ADDENDUM NO.: 02

PROJECT: A New Branch Office
Johnson City Branch
622 N. Nugent Avenue
Johnson City, Texas 78636

Responses to Questions form Bidders:

A3.4

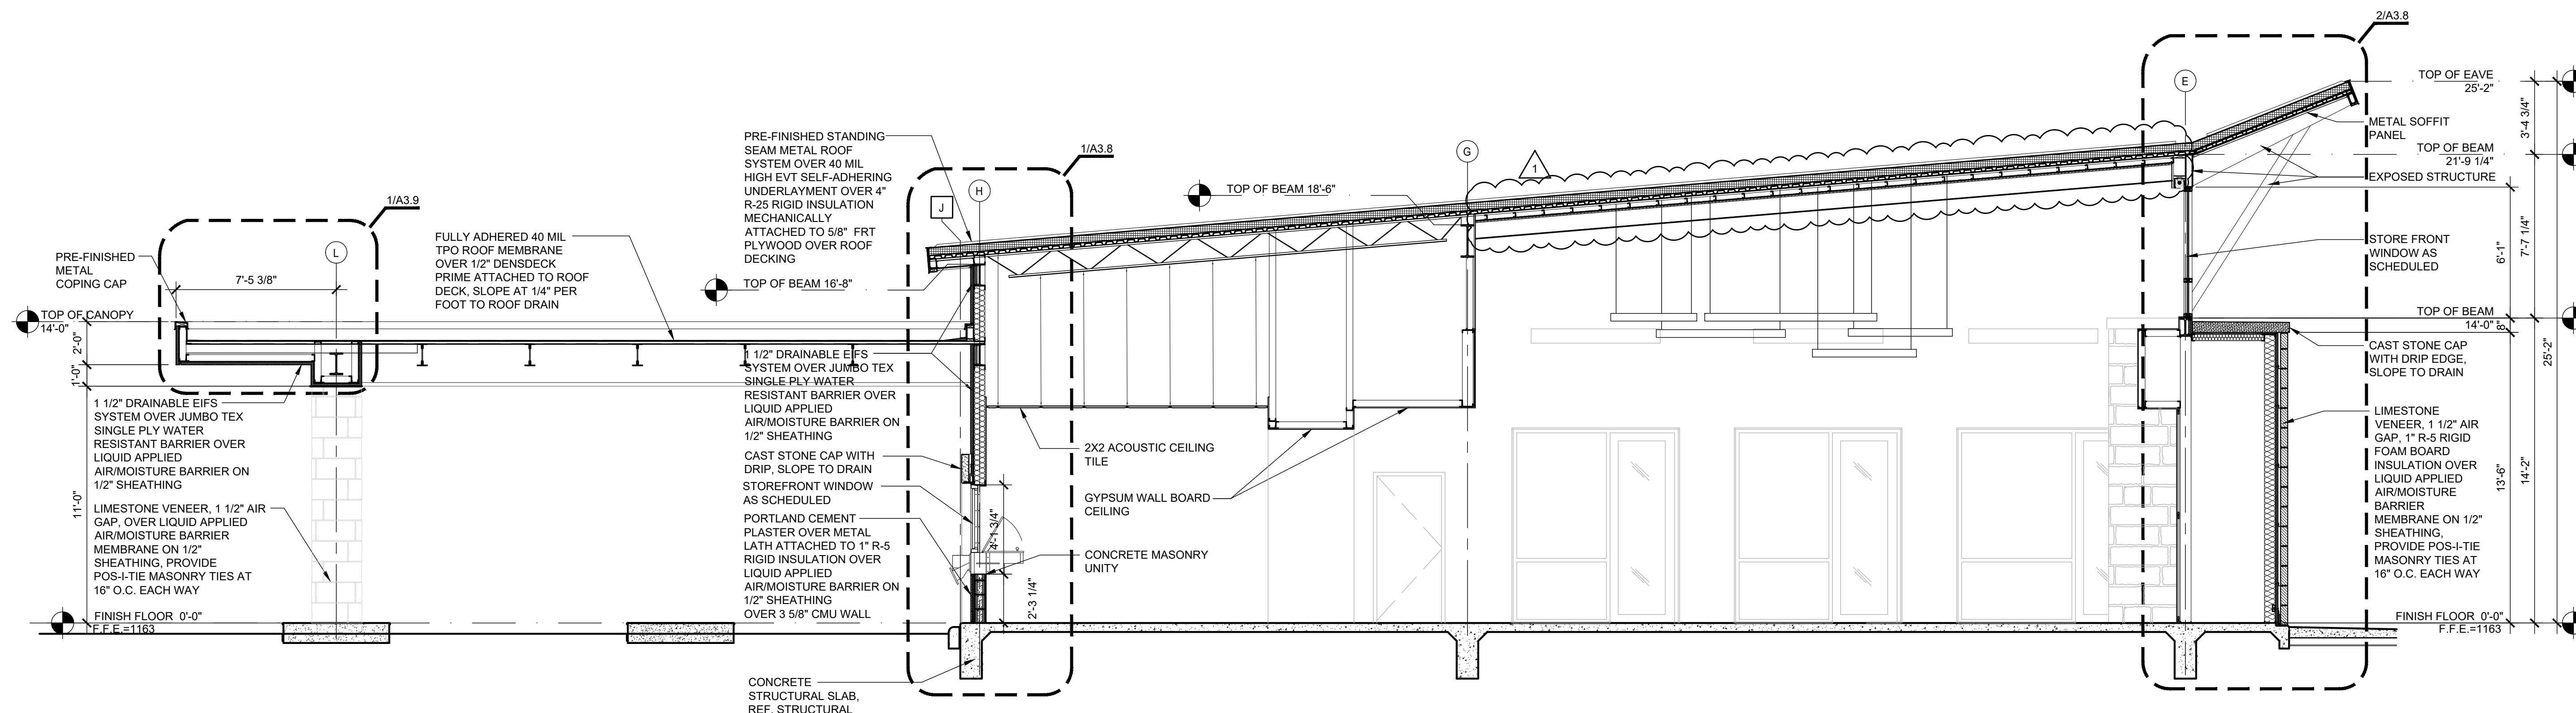
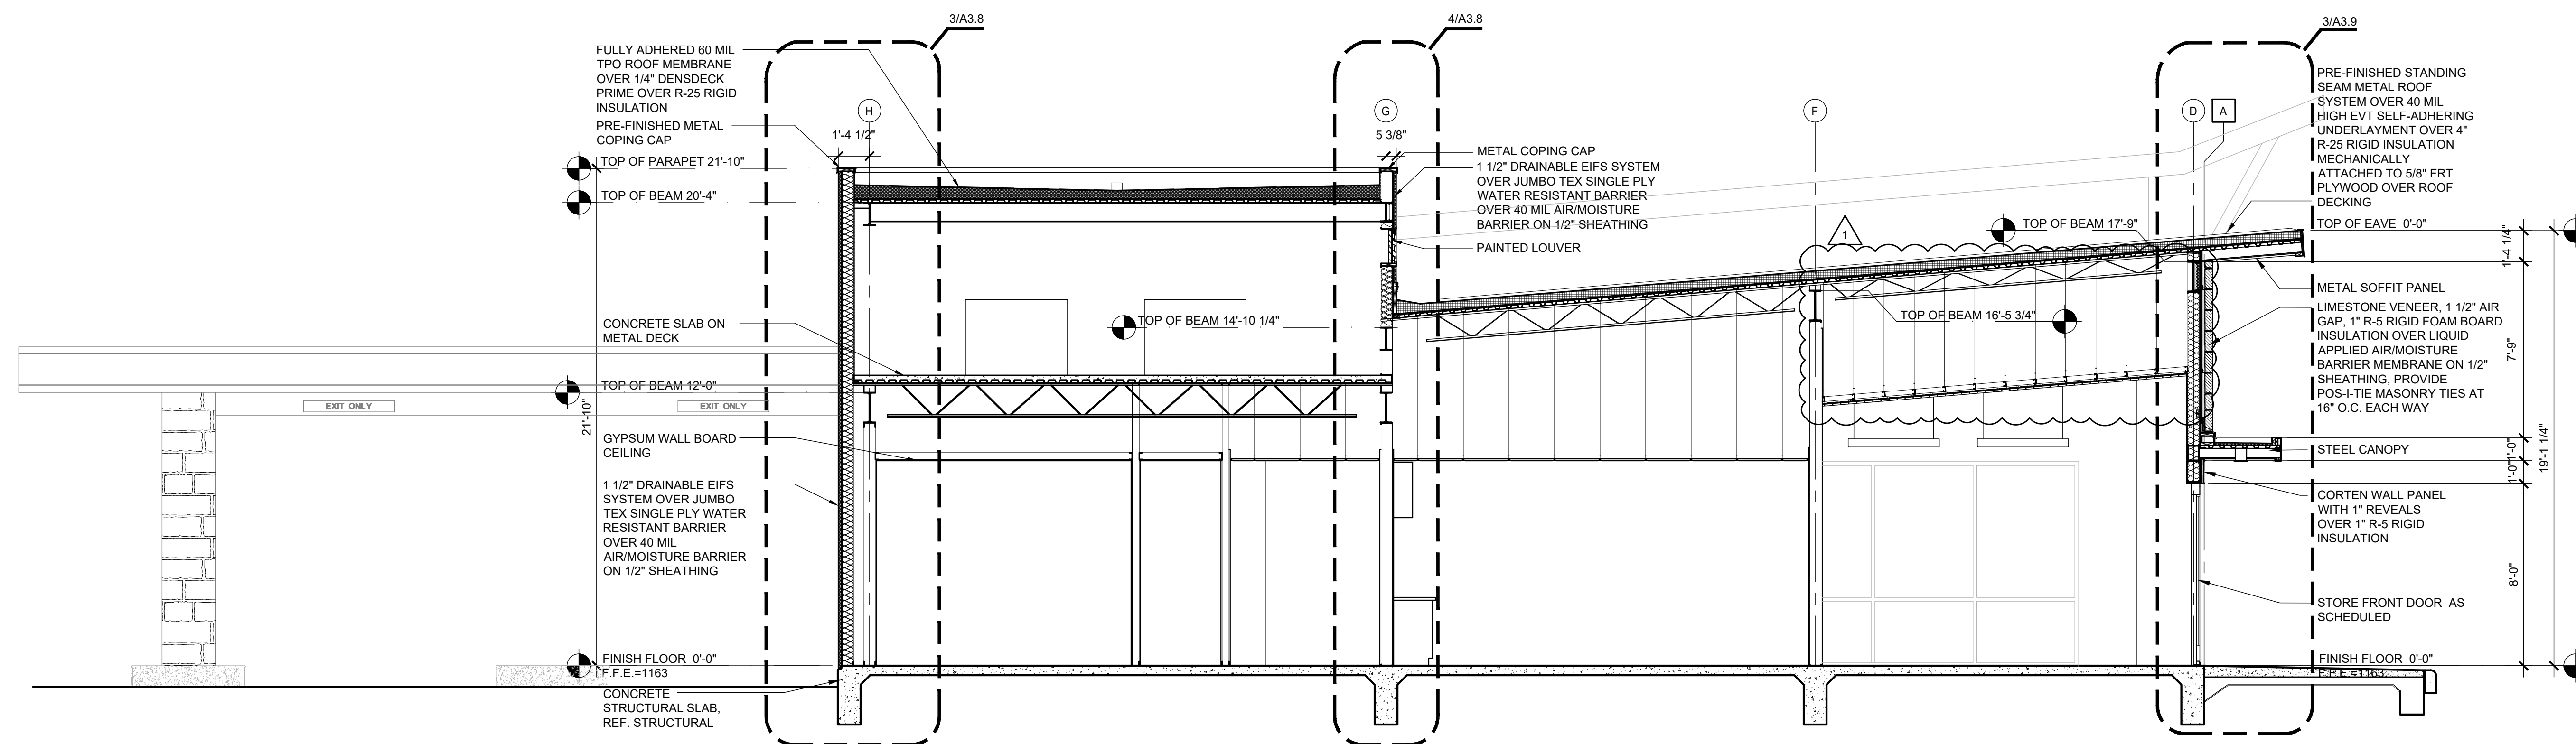
Question 10 - Lobby 101 is shown to receive the WD1 acoustic panels. The finish schedule calls for this ceiling to be sloped following the roof structure. The cut section in this area, 1/A3.4, does not show the ceiling panels. Should we assume that these ceiling panels will be fastened directly to the bottom of the metal deck?

Reply: See attached sheets A3.4, A3.5, A6.3

1 Foundation Plan
1/8" = 1'-0"

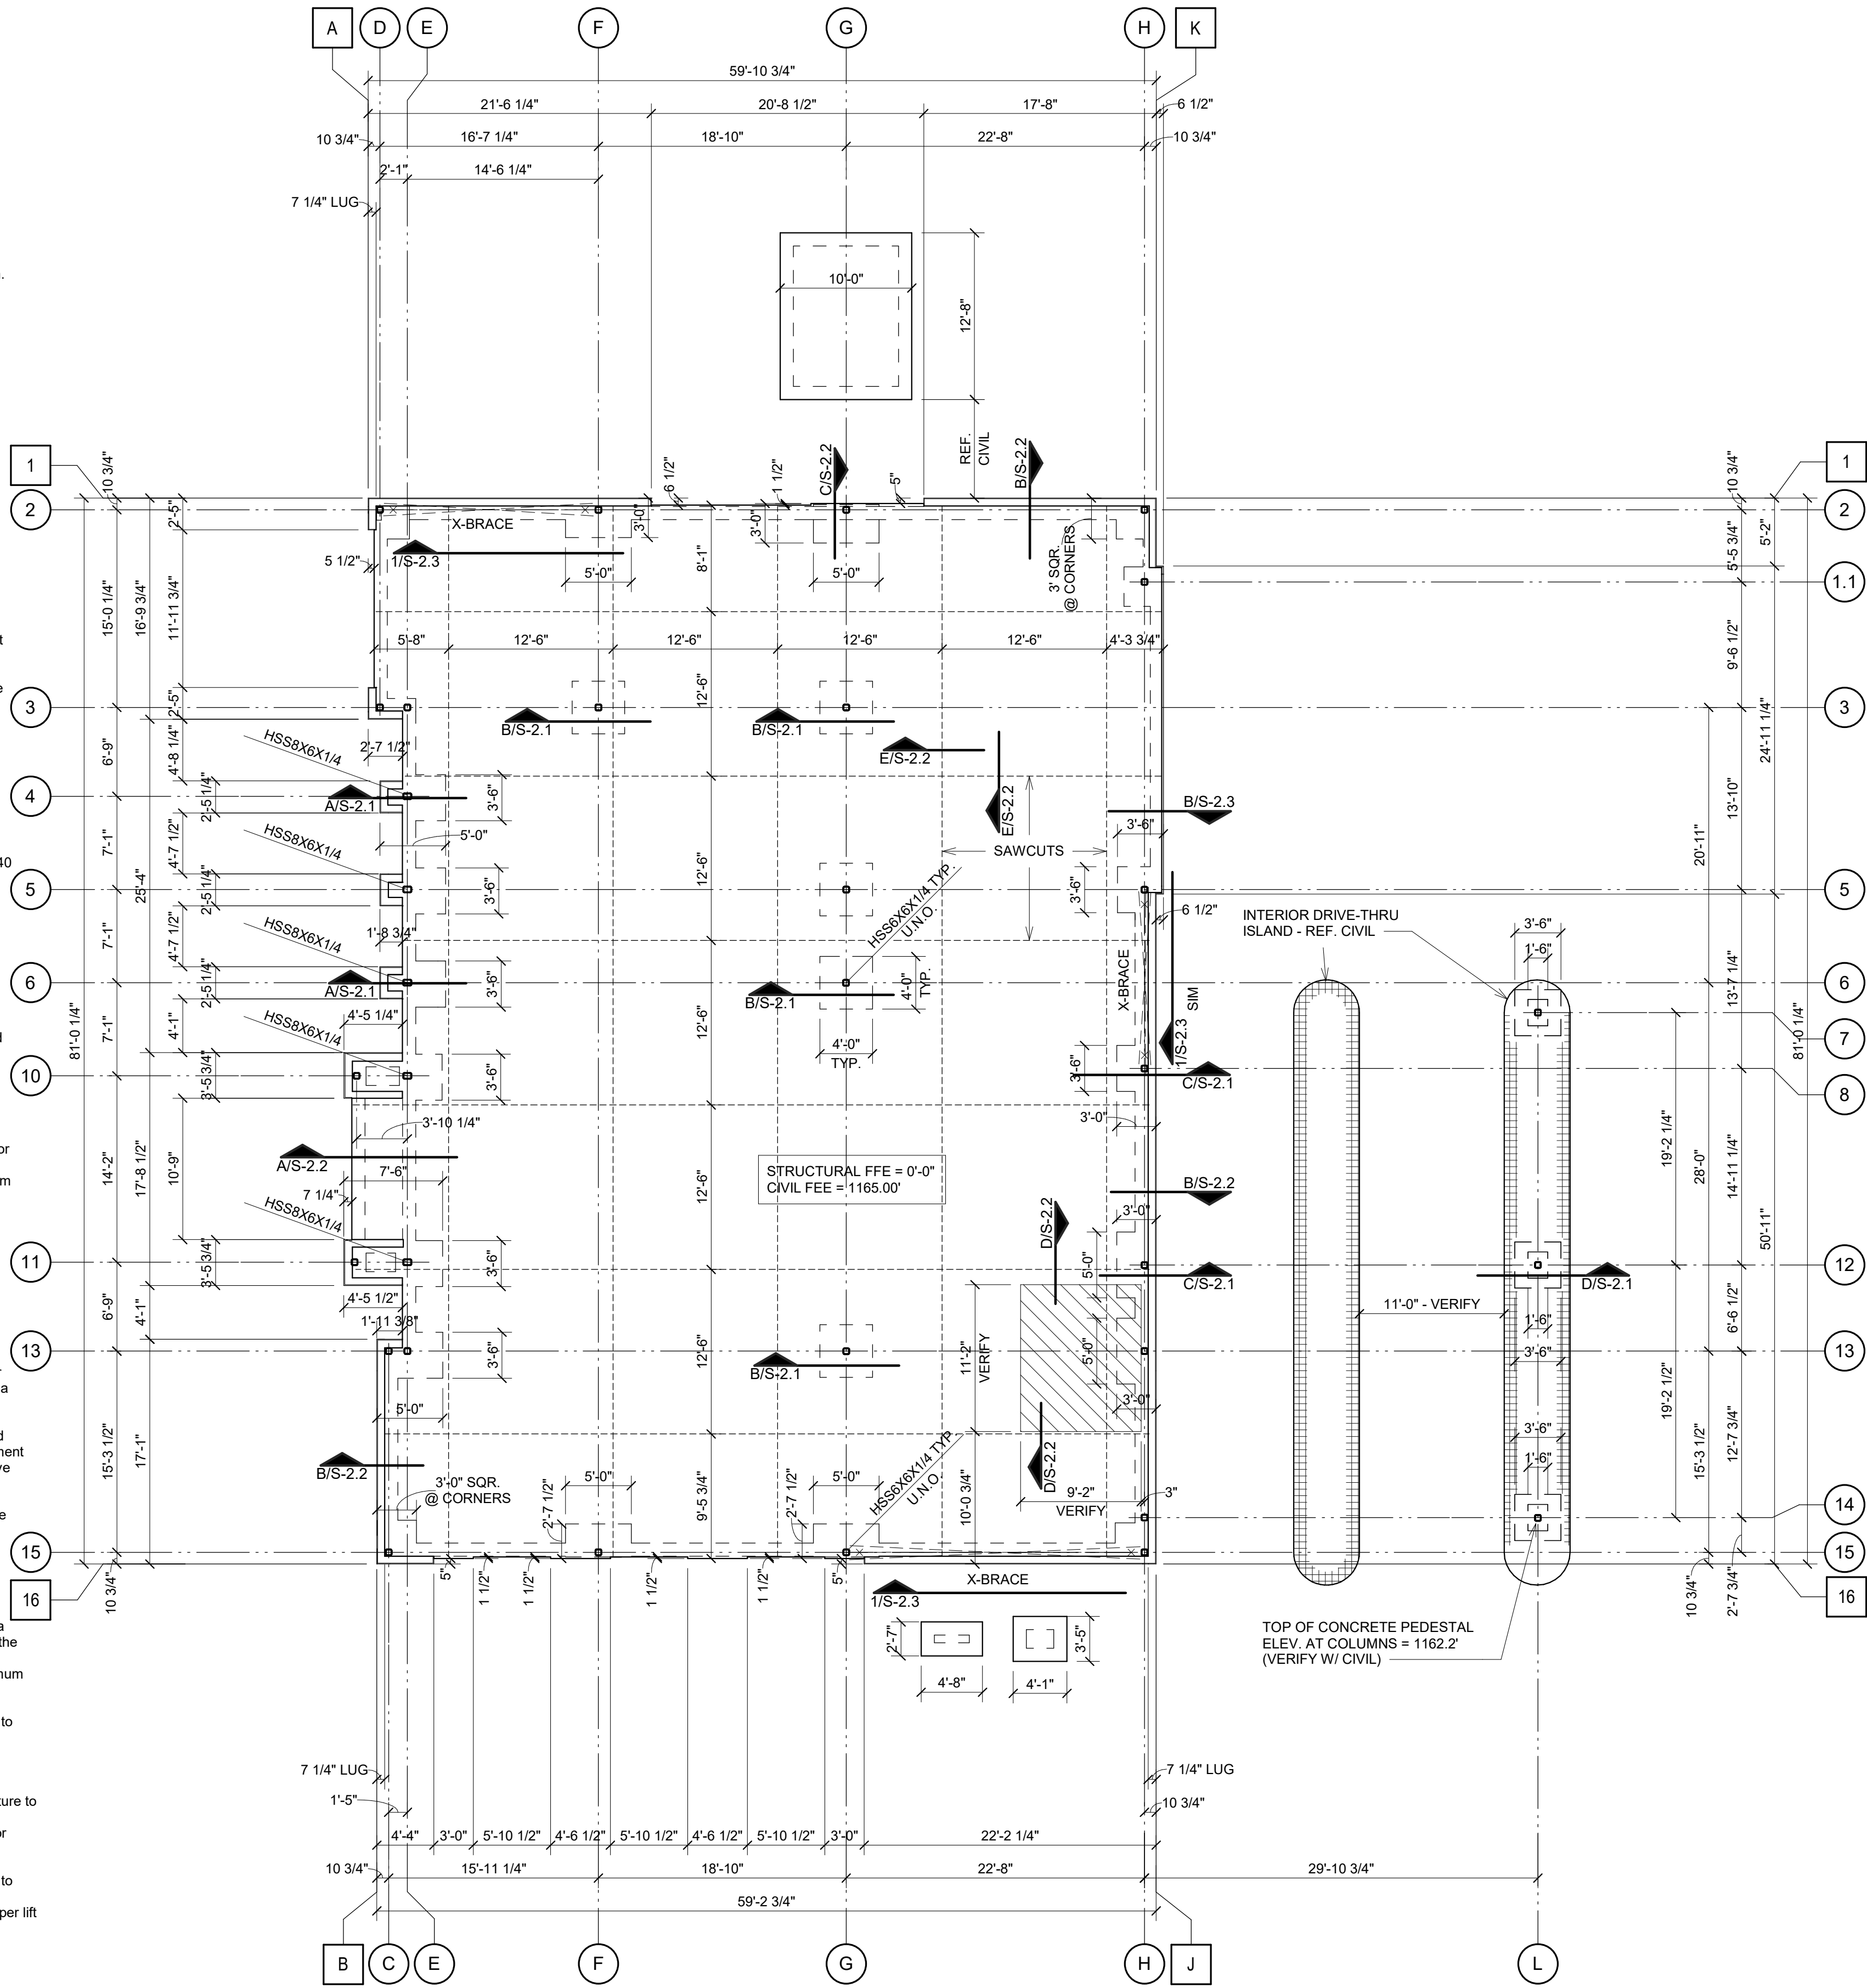
Question 16 - Please confirm the discrepancy between the Structural notes (3.5' of select fill) and the Geotechnical report (6'-0" to 7'-0" of select fill).

Reply: See attached sheet S-1.1

E HIGH-END ROOF BEAMS TO COLUMN
1/2" = 1'-0"

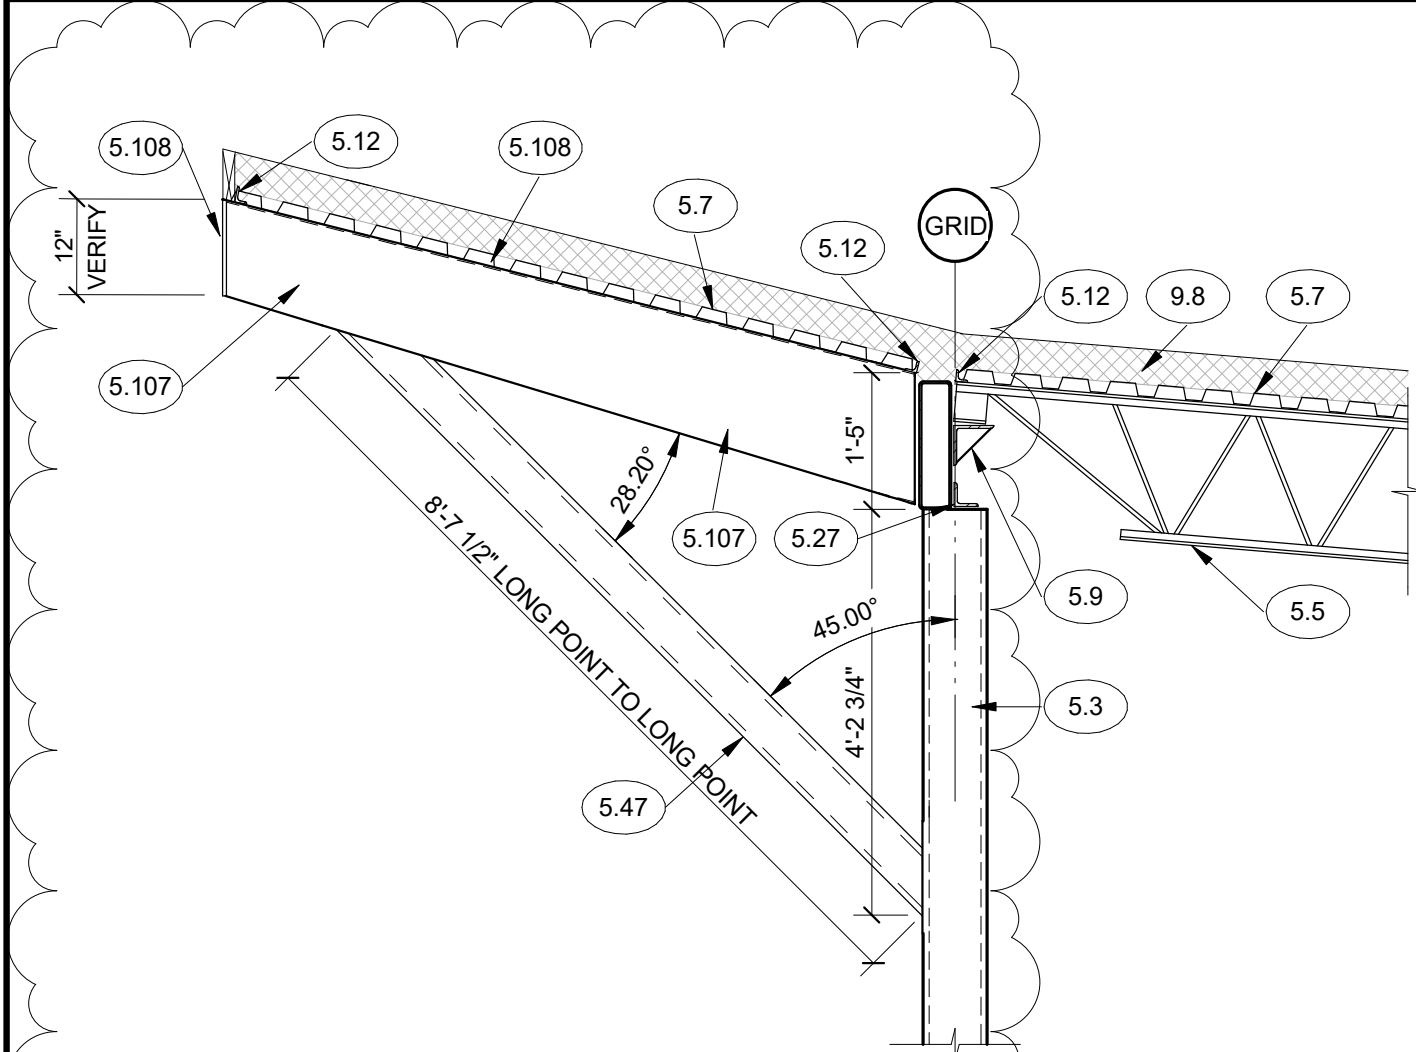
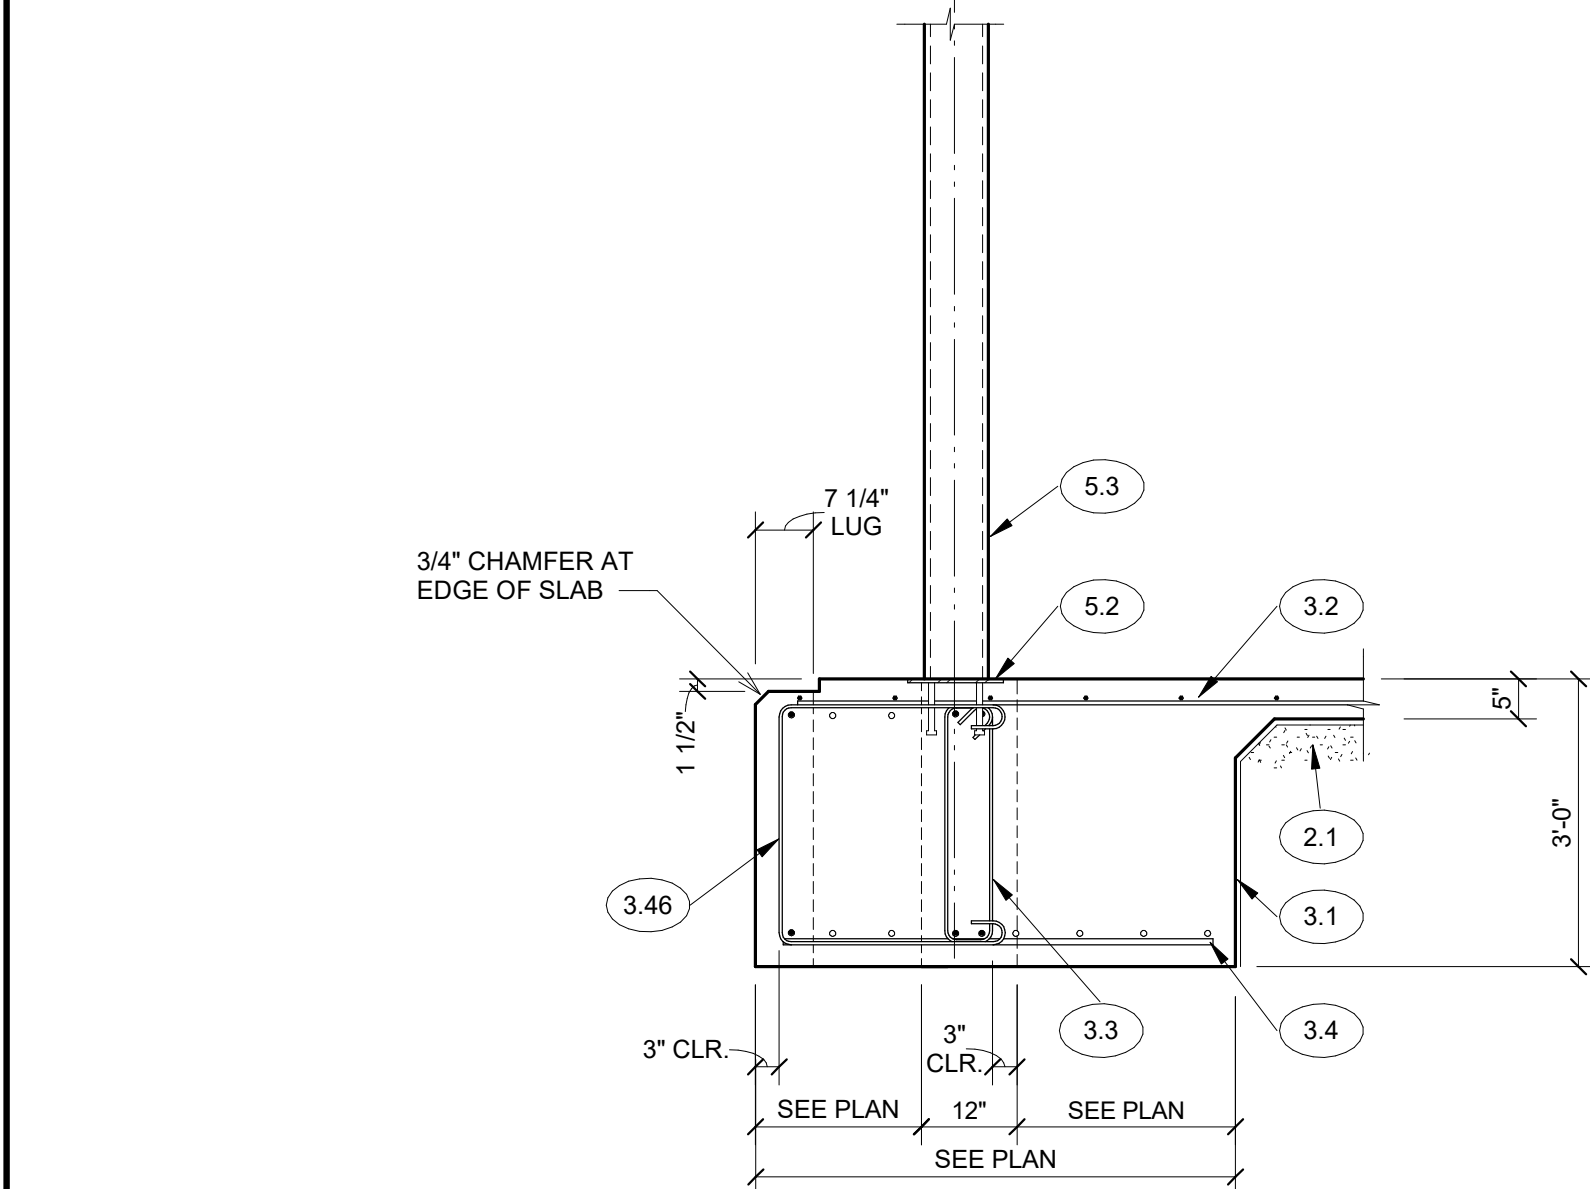
Question 9 - Drawing S-1.4, left side of grid E shows a steel beam which is exposed Drawing S-2.1, details E & J, show a better view. The beam has a HSS 6x6 kicker under it What is this beam,? Is it a beam, channel or HSS?

Also the HSS 6x6 diagonal kicker, item 5.47 is not sized for the thickness (HSS 6x6x?)

9a: The diagonal kicker is HSS6x6x1/4 please.

9b: On the tapered beam, this member being flush with the width of the column and diagonal kicker for smooth interfaces between the member intersections. Since we have an HSS8x6 column at these locations with the 6" side facing out, set this tapered beam to be 6" wide. Then we have it intersecting a 16" deep tube on the front upper edge of the building but AISC doesn't make HSS16x6 tubes so we would need to use a SS18x6x3/16 steel tube with the bottom edge cut at the required dimensions and tapered as shown.

This will be more than sufficient for this condition. **See attached sheet S2.1**
